**DEFENSE NUCLEAR FACILITIES  
SAFETY BOARD**

### Safety Issues Relating to the Waste Isolation Pilot Plant Safety Significant Confinement Ventilation System

## Appendix A: WIPP Underground Transport Calculation

**Figure A-3.** Simplified diagram with potential CAM locations for the three cases evaluated.

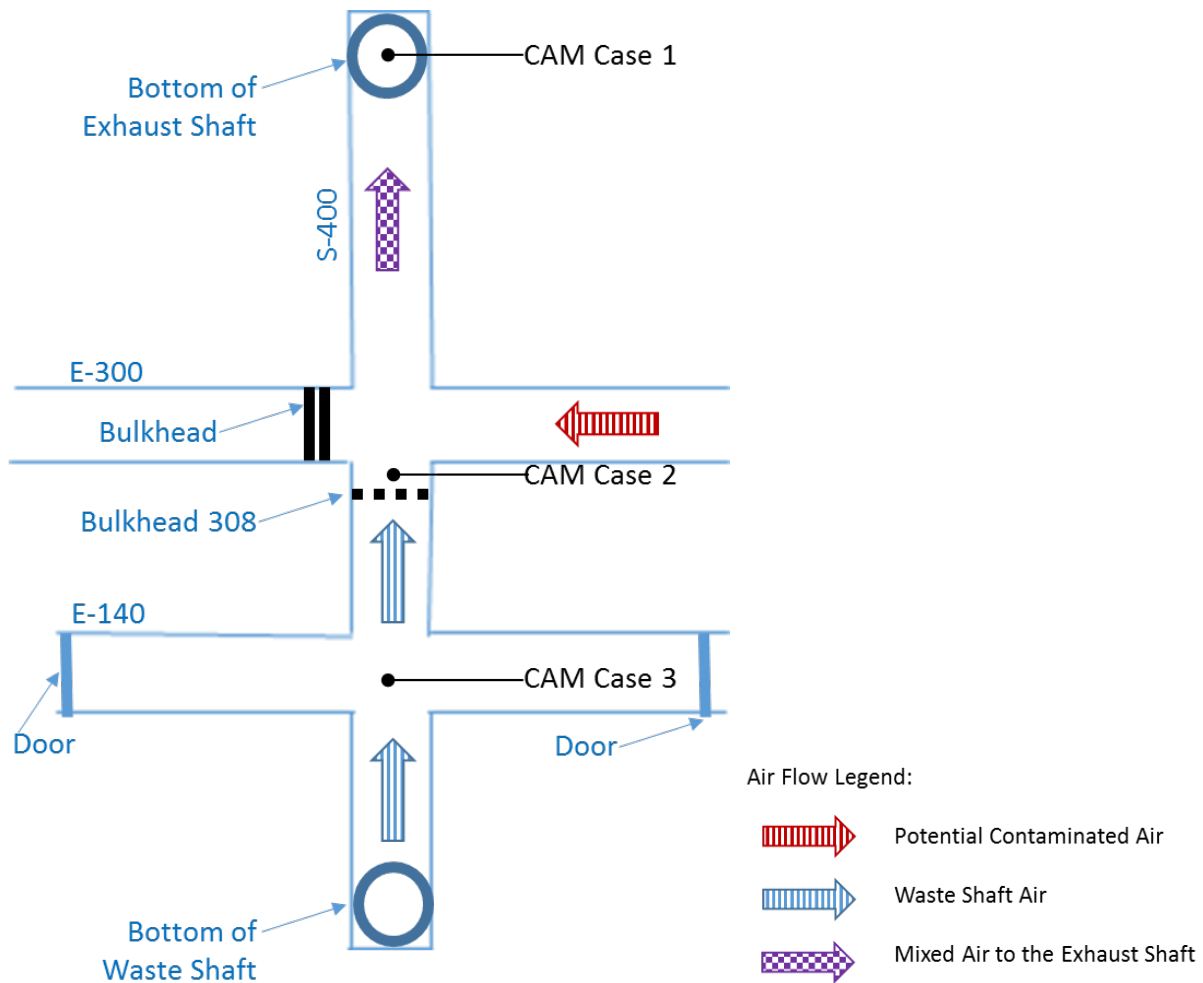
This analysis evaluates three cases. The radiological releases of the three scenarios evaluated take place in the underground waste shaft station located between the waste shaft and exhaust shaft. The Board's staff team selected this area due to the proximity of the waste shaft station to the bottom of the exhaust shaft. The three cases evaluate the following anticipated events at the waste shaft station and transport path: fire, deflagration/over pressurization, impact, and spontaneous combustion (e.g., CH/RH-UG-02-001a, CH/RH-UG-02-002a2, CH/RH-UG-02-002a3, CH-UG-01-001a2, CH-UG-06-001a, CH/RH-UG-10-003a, CH/RH-UG-01-005a1, CH/RH-UG-10-005a), when the underground ventilation system is credited as a mitigative control. The main differences between the three cases is the magnitude of the event and the location of the CAMs (see Figure A-3).

**First Case**—In the first case, the Board's staff team assumed that the anticipated event would be an explosion or high energy event of sufficient magnitude to push radiological contamination from the waste shaft station toward the exhaust shaft. The magnitude of this anticipated event would be similar to the design basis accidents (DBA), which contemplate a fuel operated vehicle and/or a vehicle carrying waste dropping from the waste shaft collar (i.e., CH/RH-UG-01-005a1 and CH/RH-UG-10-005a). This scenario assumed that CAMs would still work during and after the explosion and that any CAM located between the waste shaft and BH-308 would detect airborne contamination and send the signal to automatically start closing the isolation dampers. As illustrated in Figure A-3, BH-308 is located between the waste shaft and the exhaust shaft. However, BH-308 is not a safety component and for that reason it cannot be credited during these events. For this reason the Board's staff team also assumed that BH-308 is nonexistent and contamination is pushed almost instantaneously to the bottom of the exhaust shaft during this scenario. Thus there is no practical difference between detection times for any of the three potential CAM locations.

The second and third cases contemplate medium to low energy events without the potential to instantaneously push contamination to the bottom of the exhaust shaft. Instead, the contamination is detected at two different locations in the waste shaft station as described in the second and third cases.

**Second Case**—The second case assumed detection by a CAM located next to BH-308 and takes into consideration the distance between BH-308 and the bottom of the exhaust shaft. The cross-sectional area of the S-400 drift and maximum SSCVS volumetric flow rate are used to calculate the air stream velocity; factoring in the travel distance yields the transport time. This volumetric flow rate is used due to the short distance between BH-308 and drift E-300 (see Figure A-3). The Board’s staff team assumed that any radiological release detected in the vicinity of BH-308 accelerates almost immediately to the air stream velocity of the E-300 drift in the direction toward the exhaust shaft.

**Third Case**—The third case assumed detection by a CAM located at the intersection of the S-400 and E-140 drifts. This case takes into consideration the additional distance between the intersection and BH-308. Once again the air stream velocity is inversely proportional to the cross-sectional area of the flow path. In the third case, the smallest area and higher velocity is at the BH-308 dampers. The cross-sectional area at BH-308 also could fluctuate based on the damper free area<sup>1</sup>.

**Figure A-4. Bulkhead 308 Front View**

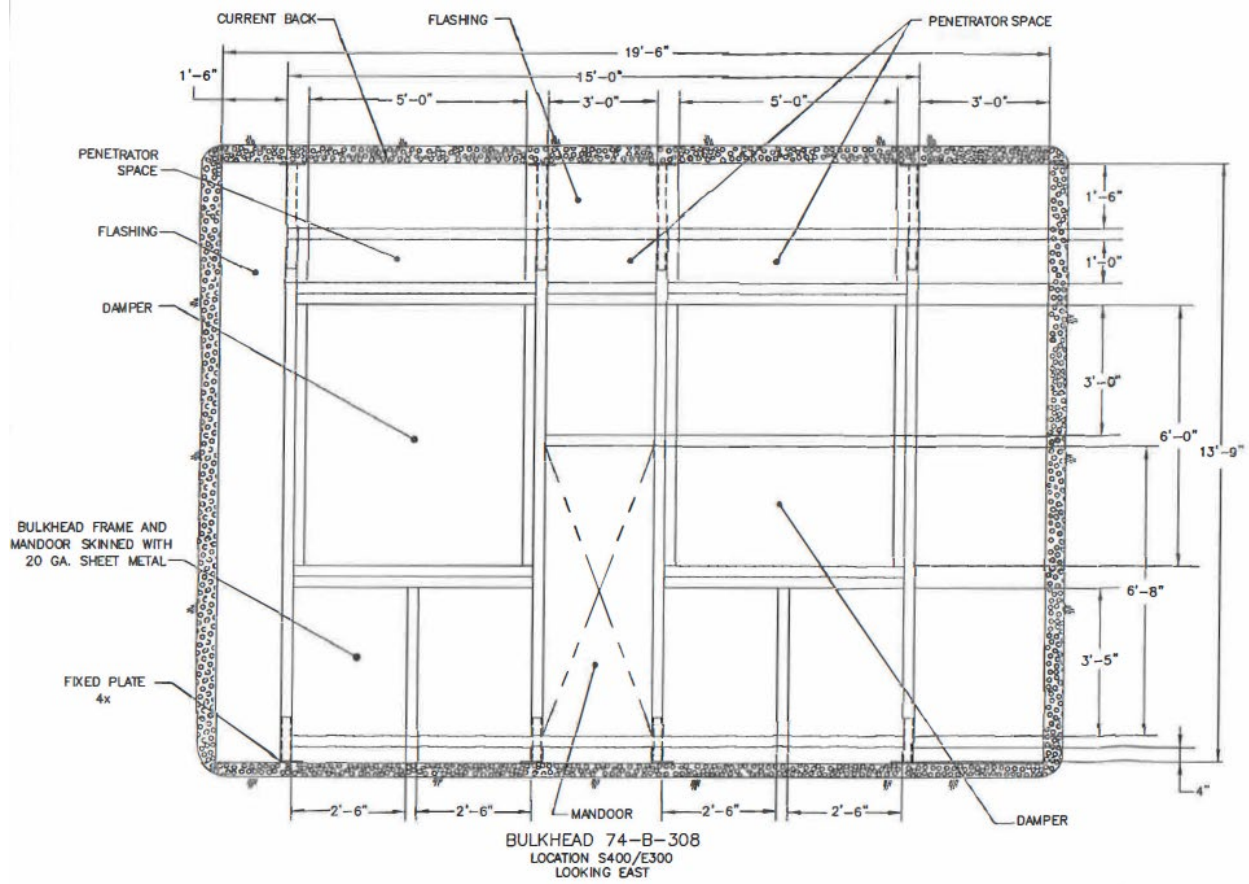
In this case, two main cross-sectional areas are used to calculate two different transport times. One area calculation uses the S-400 drift cross-sectional area and the second calculation uses the BH-308 damper cross-sectional area. The Board's staff team used the area of BH-308 as an approximation of S-400 drift cross-sectional area (Figure A-4). The dimensions of this area are 19'6" by 13'9" for an area of 268.13ft<sup>2</sup> [7]. Each BH-308 damper has dimensions of 5' by 6' for an area of 30ft<sup>2</sup> for a single damper and 60ft<sup>2</sup> for two dampers. However, assuming the damper blades occupied 50 percent of the area, the damper free area for the two dampers would be 30ft<sup>2</sup>. The volumetric flow rate of 25,000cfm, used between the intersection and BH-308 for this calculation, is the approximate target volumetric flow rate used to keep the differential pressure across BH-308 and the same flow rate used in the SRK transient time analysis [4] when BH-308 dampers are mostly open.

The maximum allowed volumetric air flow rate calculated for a 50 percent damper's cross sectional area is 17,000cfm, which is below the recommended 25,000cfm to maintain the required differential pressure at BH-308. Any flow rate above that value would increase the likelihood of contaminated air reaching the isolation damper before it is completely closed. This would cause a potential release of contaminated air to the environment.
